Subject: FCC 15.247, RSS-247, and RSS-Gen Class 2 PERMISSIVE CHANGE for Controlant EHF, Model CO 13.01, FCC ID: 2AD9R-CO1301 and IC: 20355-CO1301

This Permissive Change letter has been generated on behalf of Controlant EHF, to document the following changes to their currently certified product model CO 13.01.

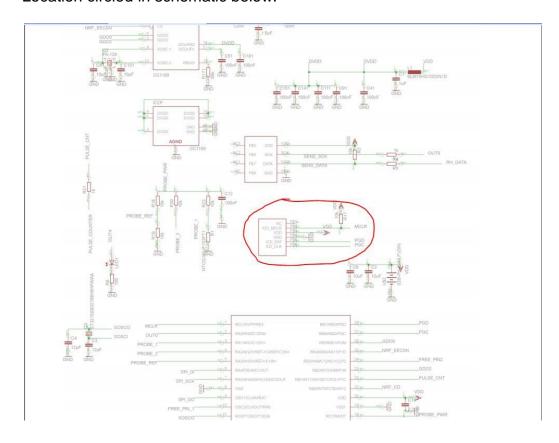
1. Added temperature and Humidity sensor- MFG: Sensirion P/N: SHT15 Location circled in schematic below:
